**From:** Hoellman, Jordan  
**Sent:** Monday, June 20, 2016 12:39 PM  
**To:** Vogle PEmails  
**Subject:** IRWST Minimum Screen Area Change and Containment Recirculation Screen Protective Plate Dimension Change - Non-Proprietary slides  
**Attachments:** 2016-06-23 Non-prop slides - Debris Screen Related Dimensions.pdf

# IRWST Minimum Screen Area Change and Containment Recirculation Screen Protective Plate Dimension Change (Non-Proprietary)

06/23/2016

**Table 6.3-2 (Sheet 2 of 2)  
Component Data - Passive Core Cooling System**

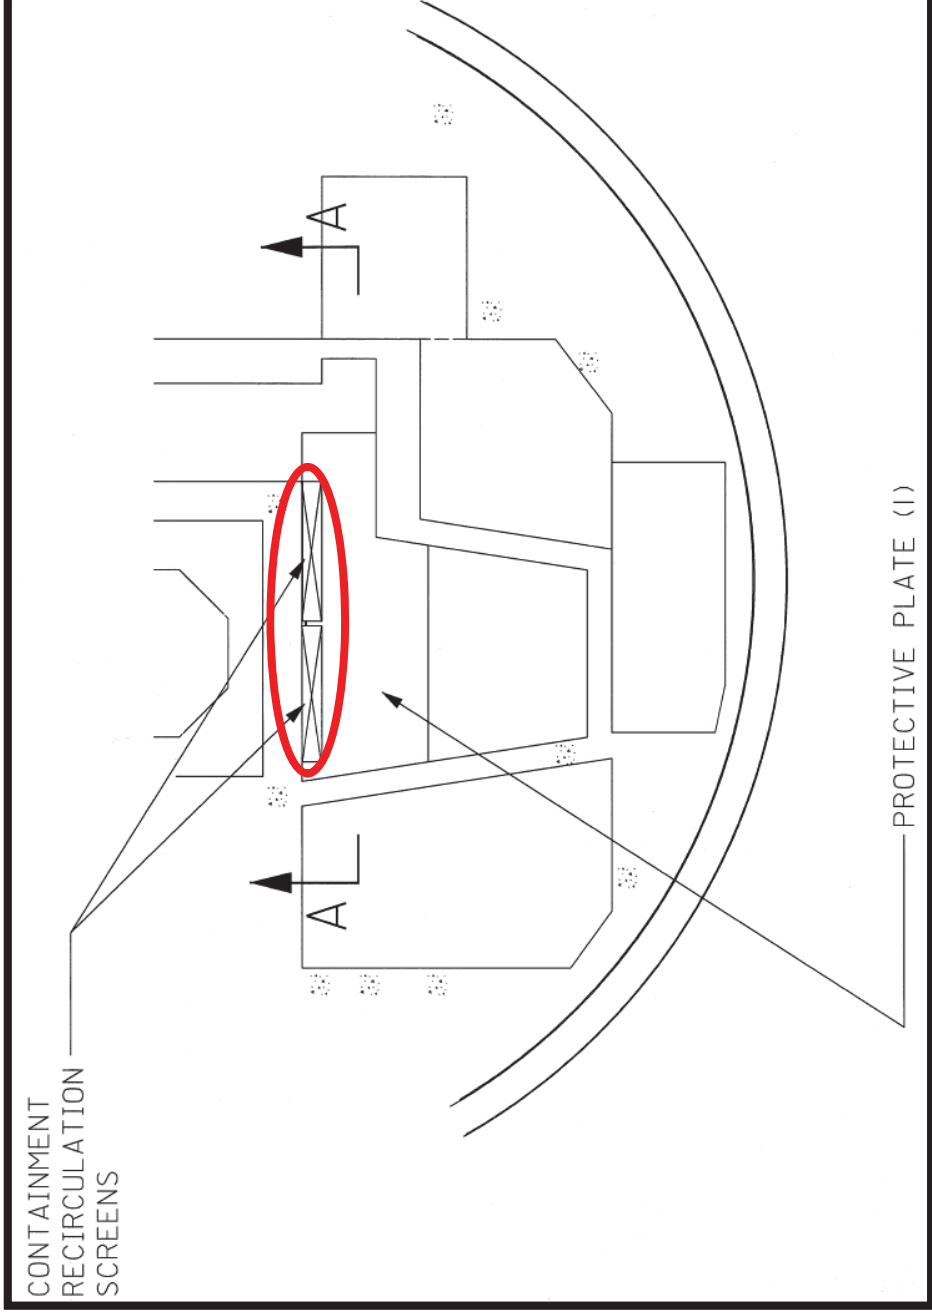
Screens	<u>IRWST</u>	<u>Containment Recirculation</u>
Number	3	2
Surface area, screen (square feet)	IRWST Screens A and B: ≥ 500 per screen IRWST Screen C: ≥ 1000 ft <sup>2</sup>	≥ 2,500 per screen
Material	Stainless steel	Stainless steel
AP1000 equipment class	C	C

IRWST Screens A and B: ≥ 500 per screen IRWST Screen C: ≥ 1150 ft <sup>2</sup>
--

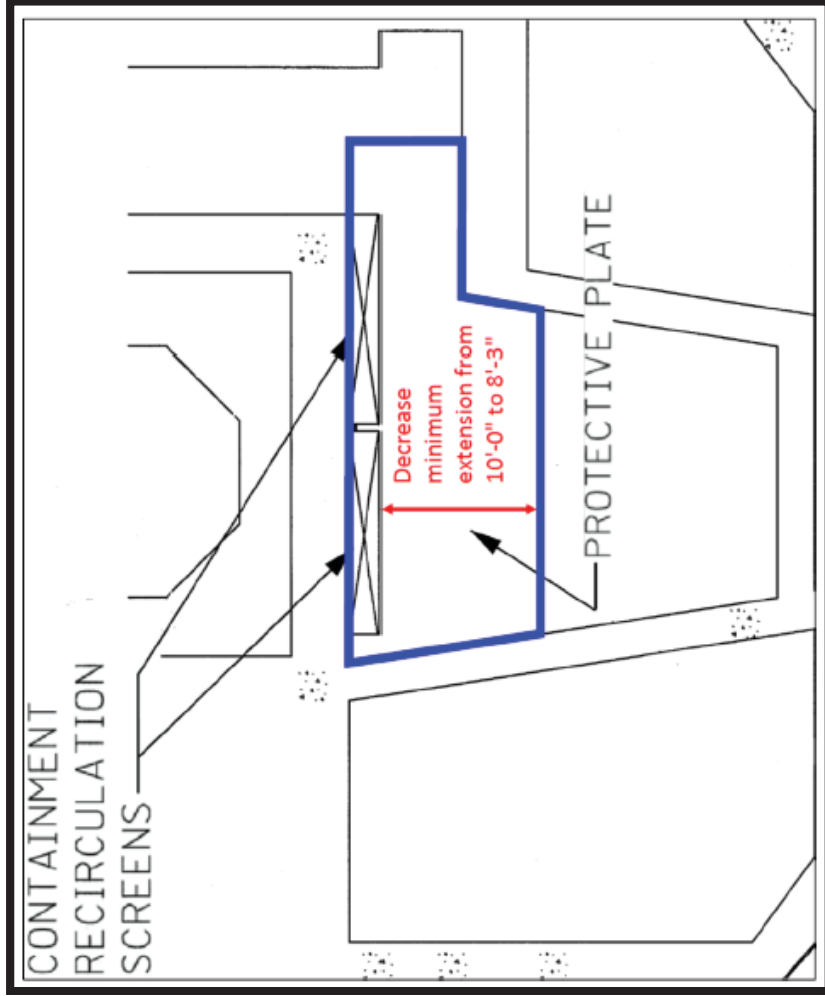
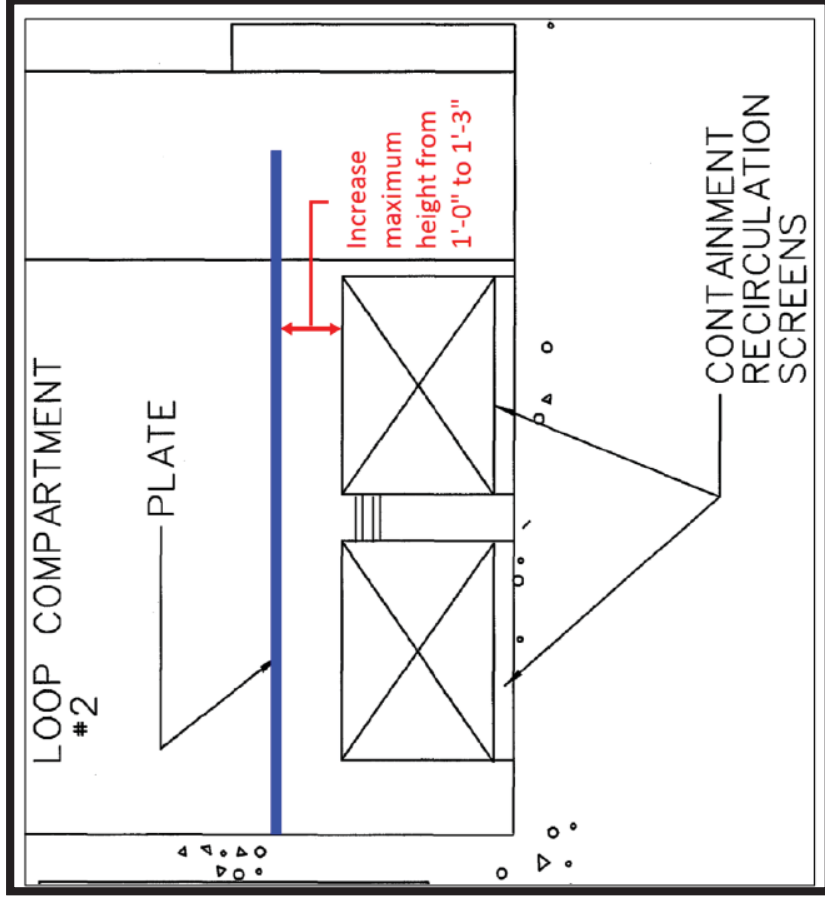
- As identified in UFSAR Subsection 6.3.2.2.7.3, the screen protective plate is provided to prevent nonsafety-related (Service Level II) coating debris that could detach in the post-accident environment from falling too close to the recirculation screens, where it could be transported to the screens.
- The UFSAR currently specifies that the plates located over the containment recirculation screen extend at least 10 feet perpendicular to the side of the screen surface
  - In order to facilitate reactor coolant pump maintenance, additional clearance is proposed in this LAR.
- The UFSAR currently specifies that the plates located over the containment recirculation screen are no more than 1 ft. above the top of the screen.
  - Changes are proposed to clearly specify where the measurements will be taken and account for the final location of the plate

- Specify in UFSAR Subsection 6.3.2.7.3 that the north edge of the north containment recirculation screen face is located at least 3 feet, 6 inches from the north corner of the west wall of steam generator compartment 2
